Ref: 29011.00

Re: MDP and Site Plan Phase 1 Comments
Silo Ridge Resort Community
Amenia, NY

On behalf of our client, Silo Ridge Ventures, LLC., "the Applicant", VHB Engineering, Surveying and Landscape Architecture, P.C. (VHB) offers the following responses to your comments dated October 17, 2014 (numbered in accordance with your letter).

**General Plan 4
Phase 1**

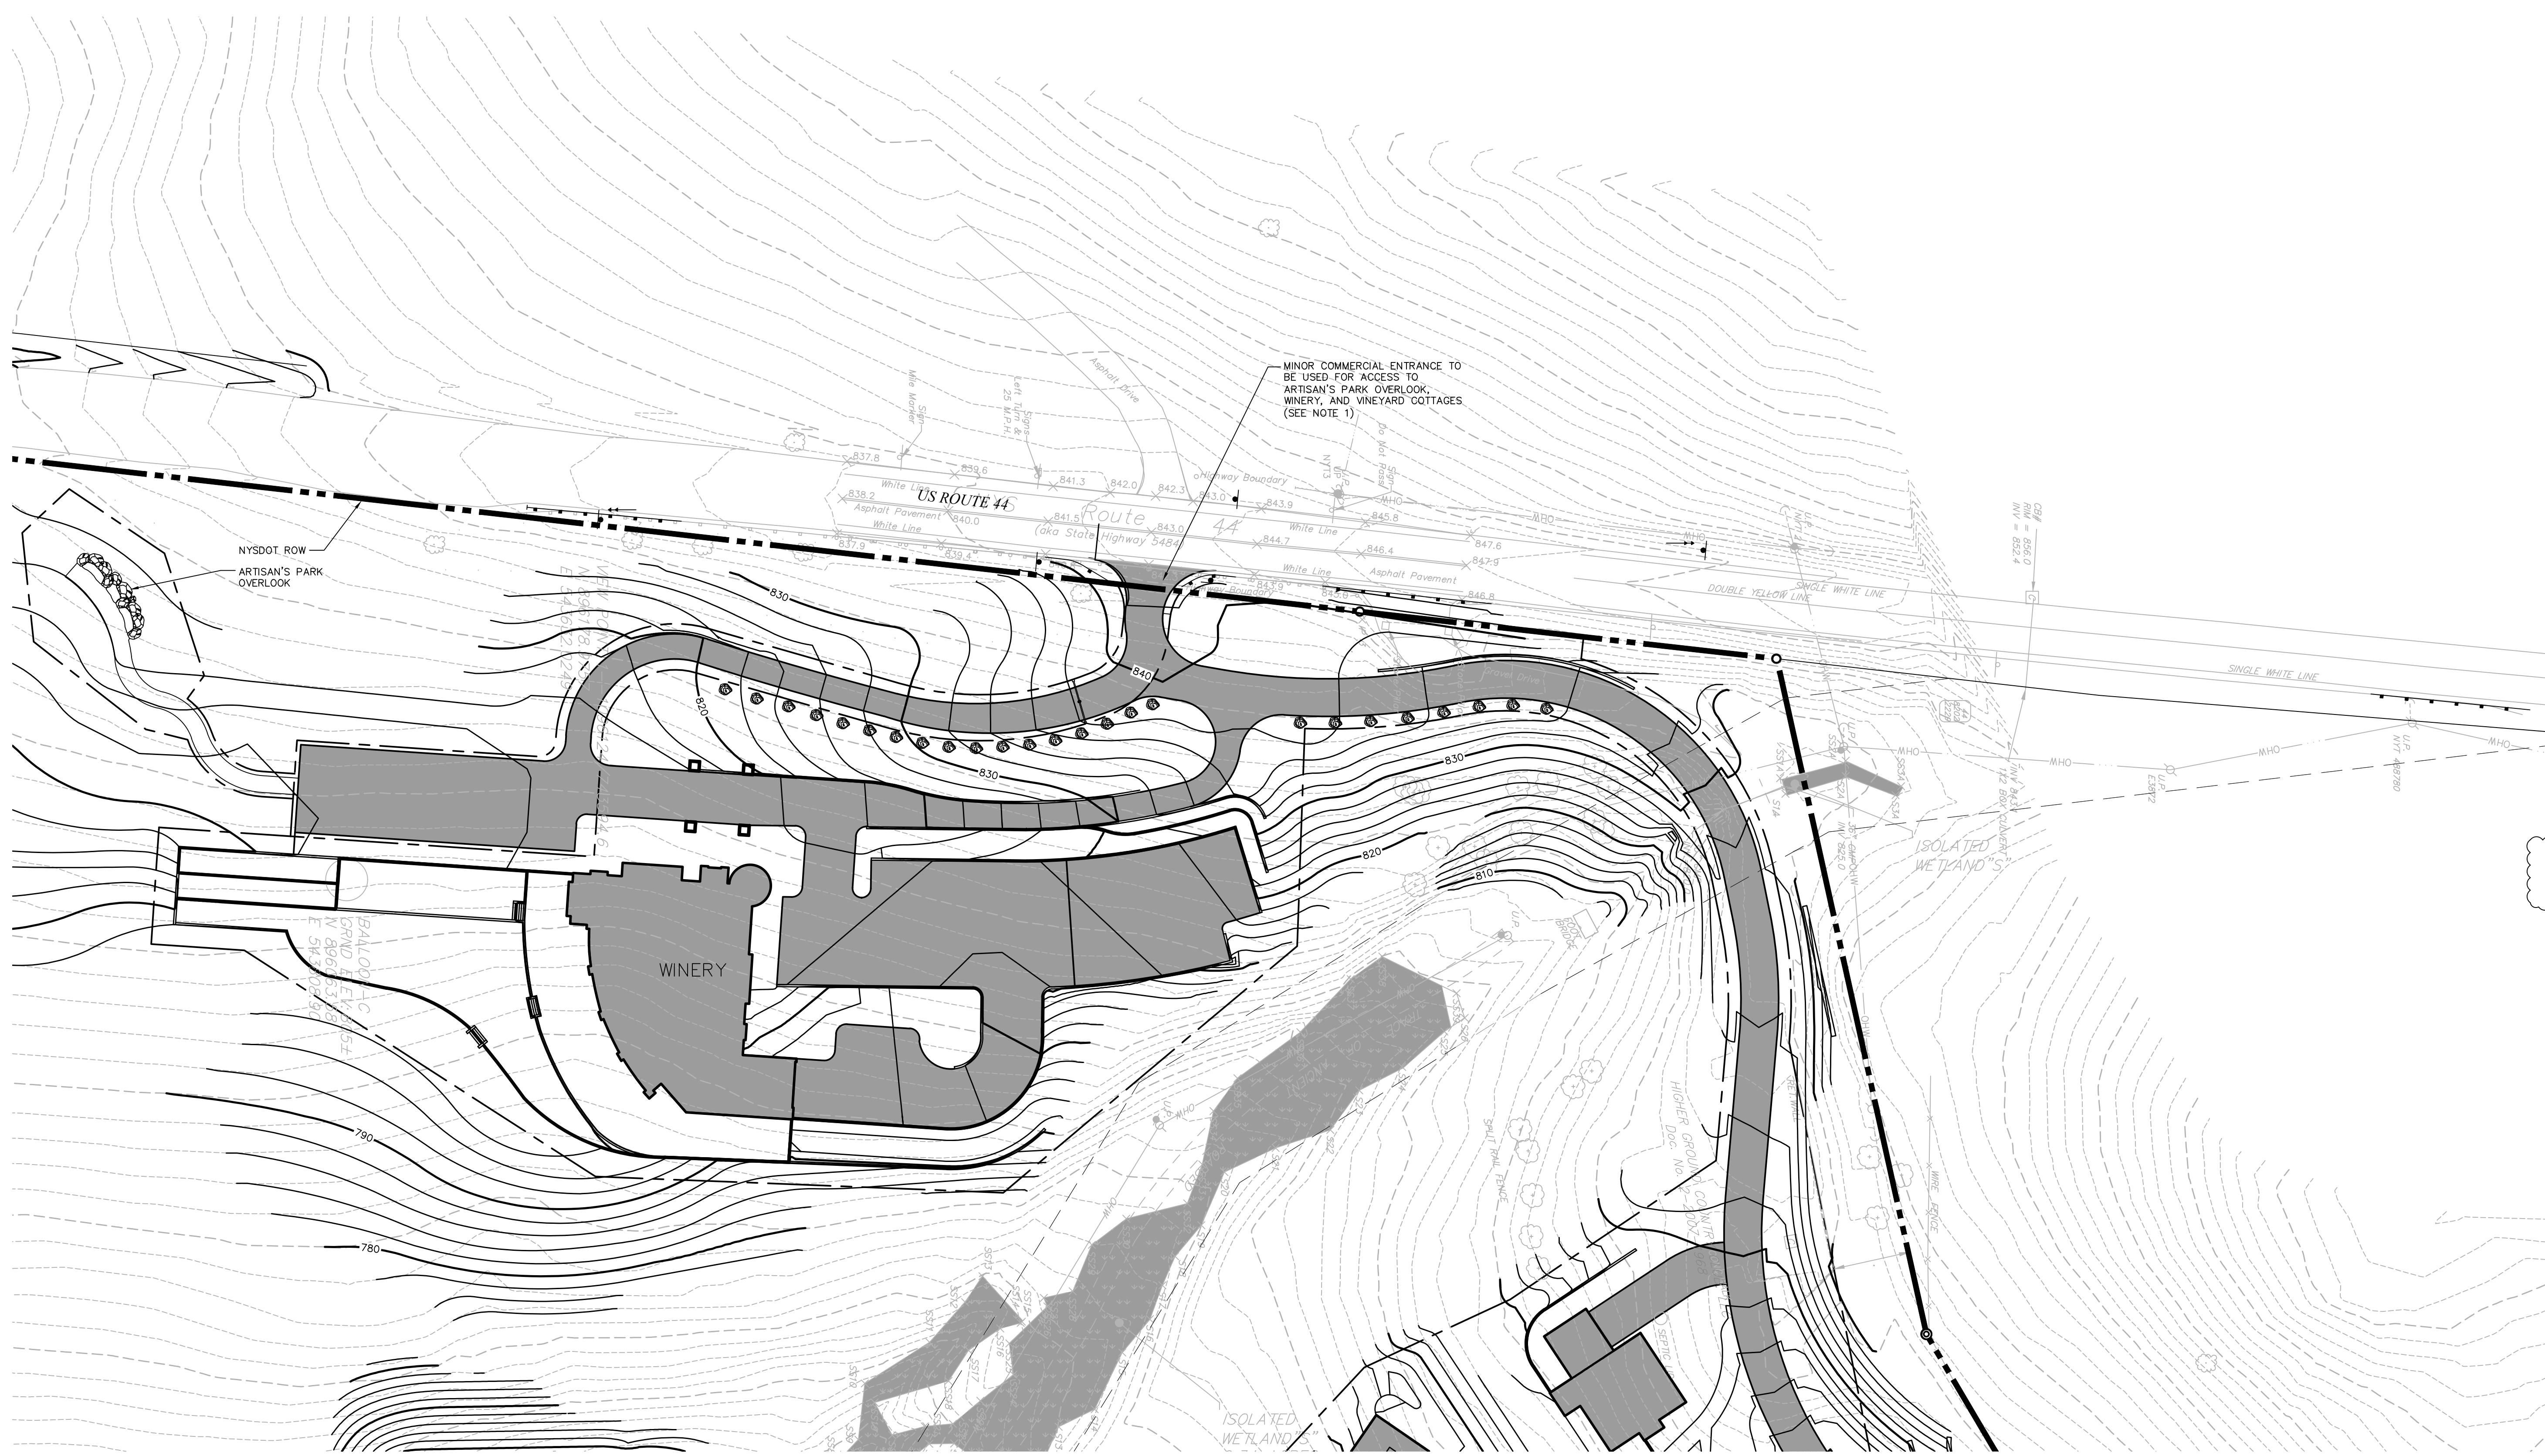
8. Comment: The existing RTE 44 pull-off area should be closed with guiderail.

19. Comment: Specify guiderail end sections. It may not be appropriate to reuse existing.

Response: The plan set has been updated to provide a guiderail at the Route 44 pull-off area (please refer to drawings GP-4A, General Plan 4 – Phase 1, and GP-4B, General Plan 4 – MDP, dated January 8, 2015).

Response: New Guide rail end sections are to be installed in accordance with NYSDOT Standards and have been specified on the plans, as indicated on sheets GP-4A, General Plan 4 Phase 1, GP-4B, General Plan 4 MDP, General Plan 5 Option 1, and General Plan 6, Option 2.

**General Plan 4
MDP**

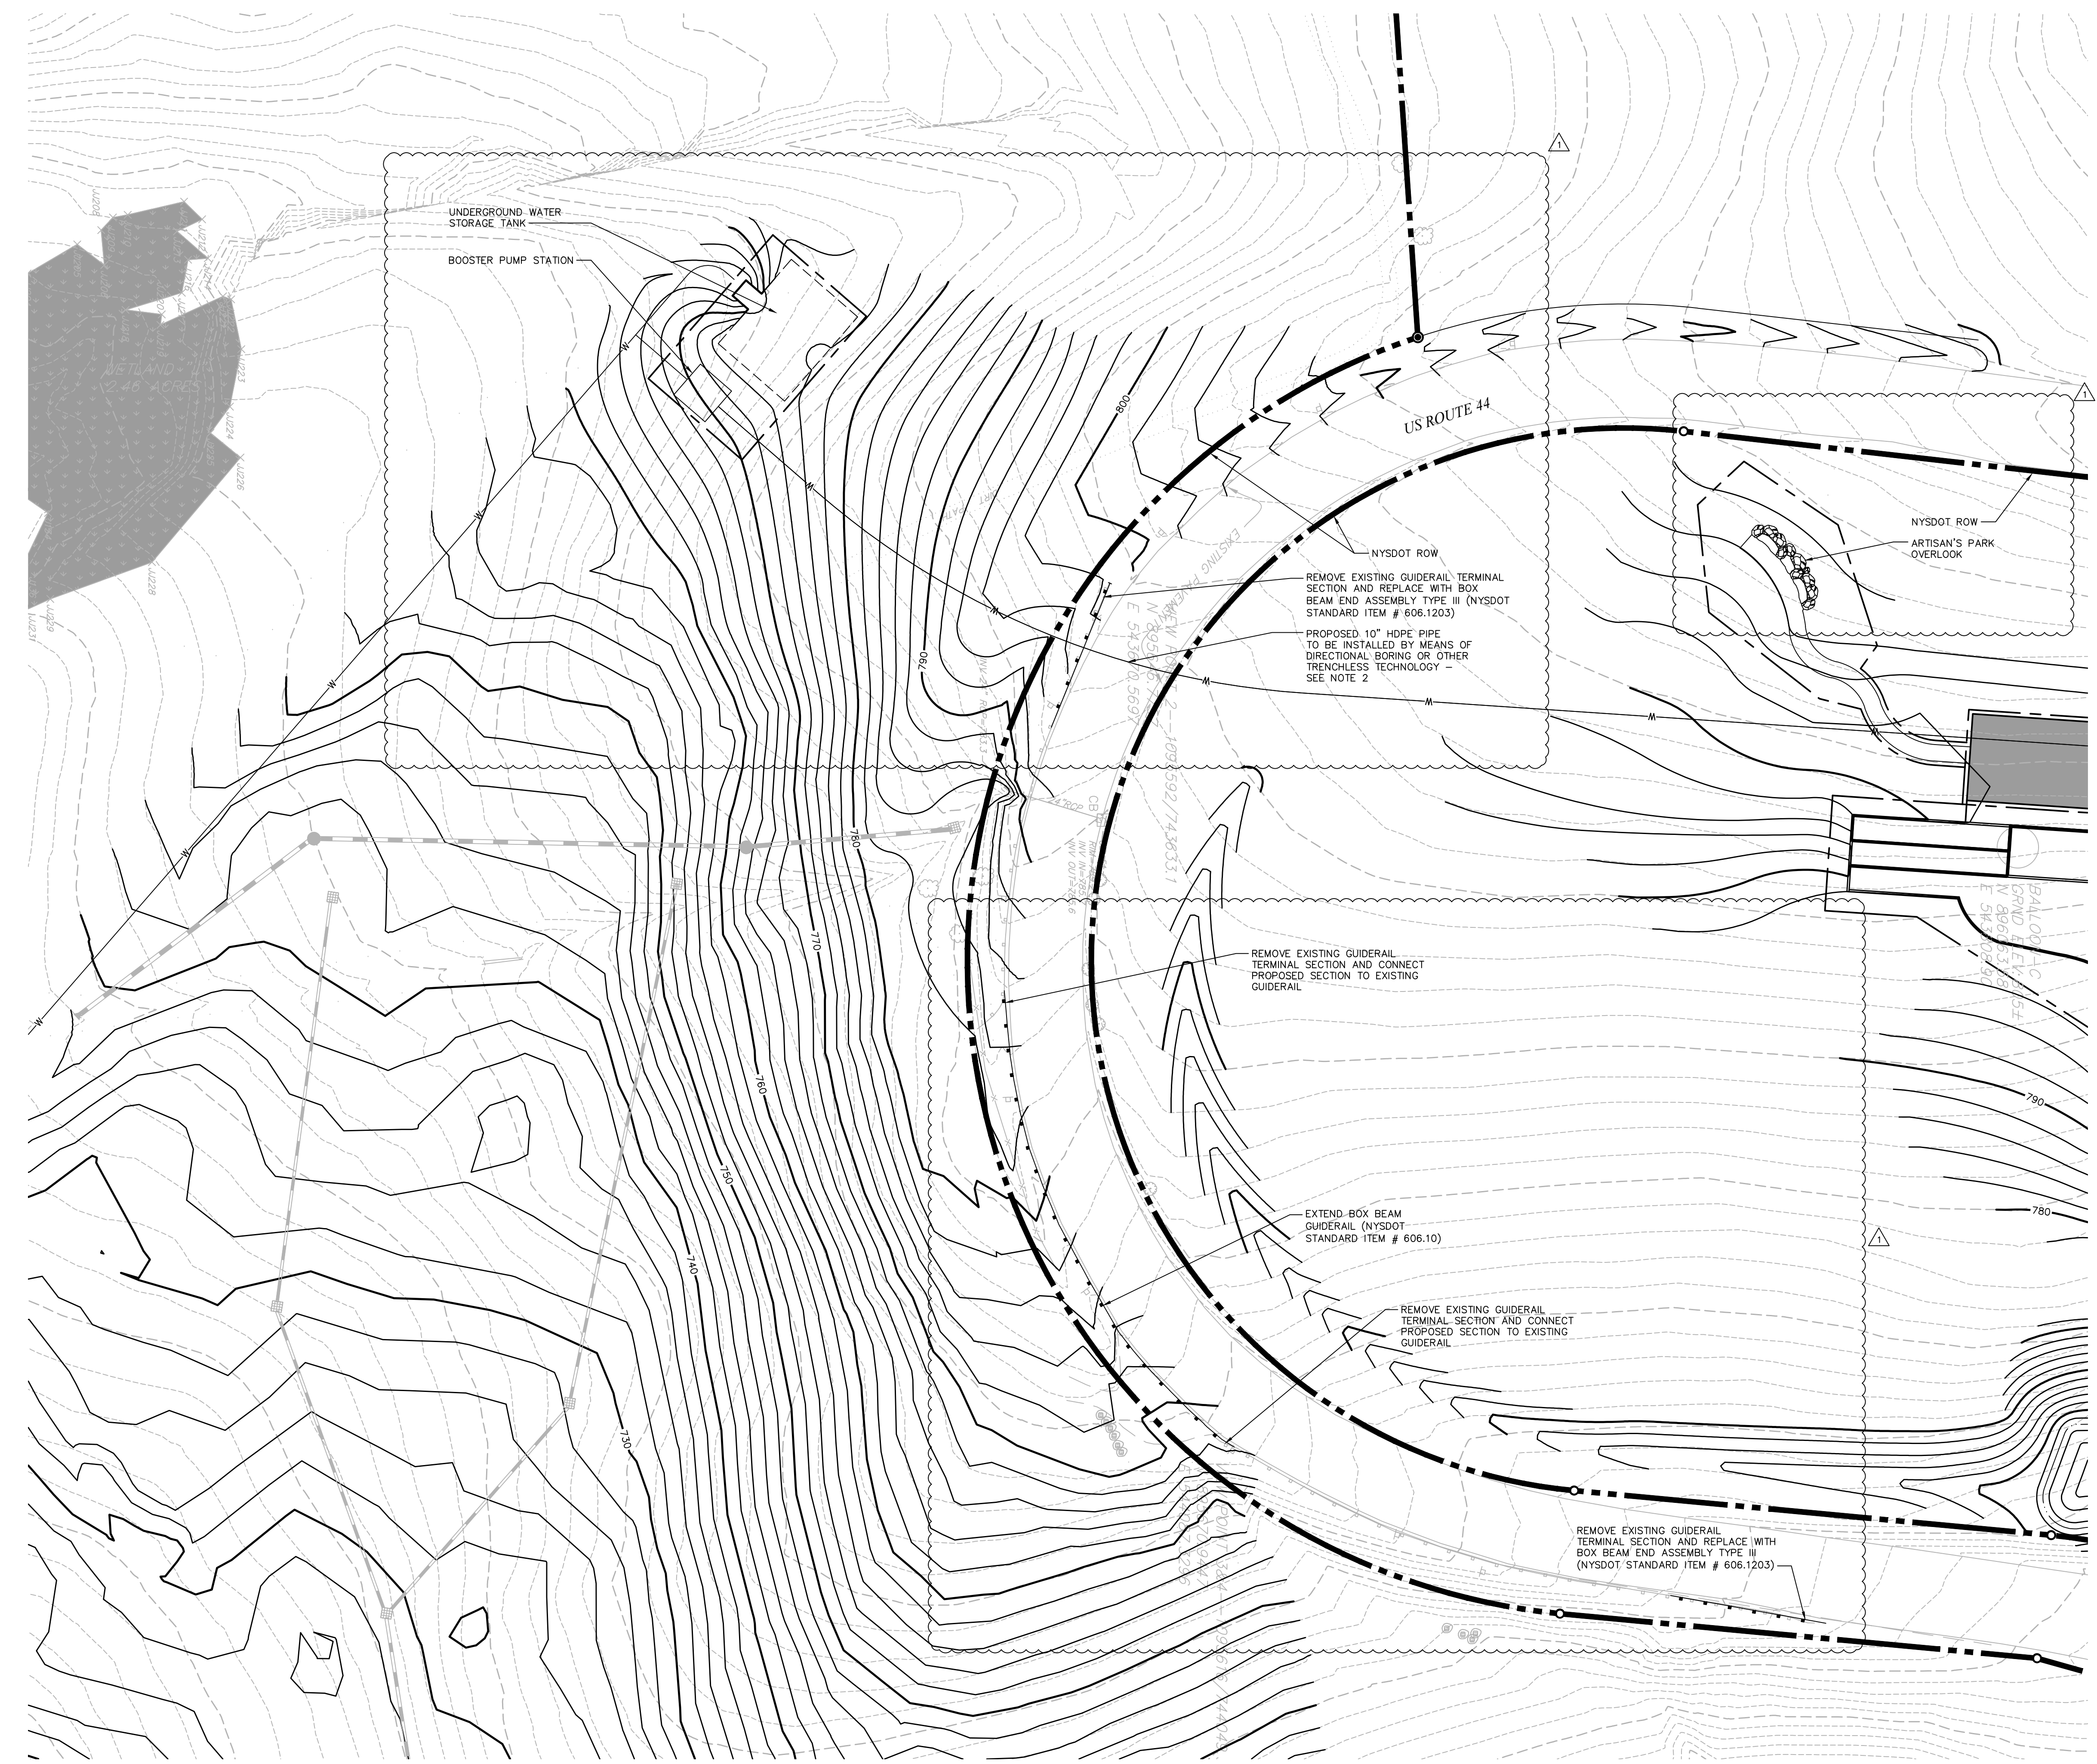
7. Comment: The winery/residential/lookout entrance to RTE 44 must be detailed as a minor commercial entrance.

Response: The winery/residential/lookout entrance on Route 44 has been detailed as a minor commercial entrance (as indicated on drawing GP-4B, General Plan 4 – MDP, dated January 8, 2015).
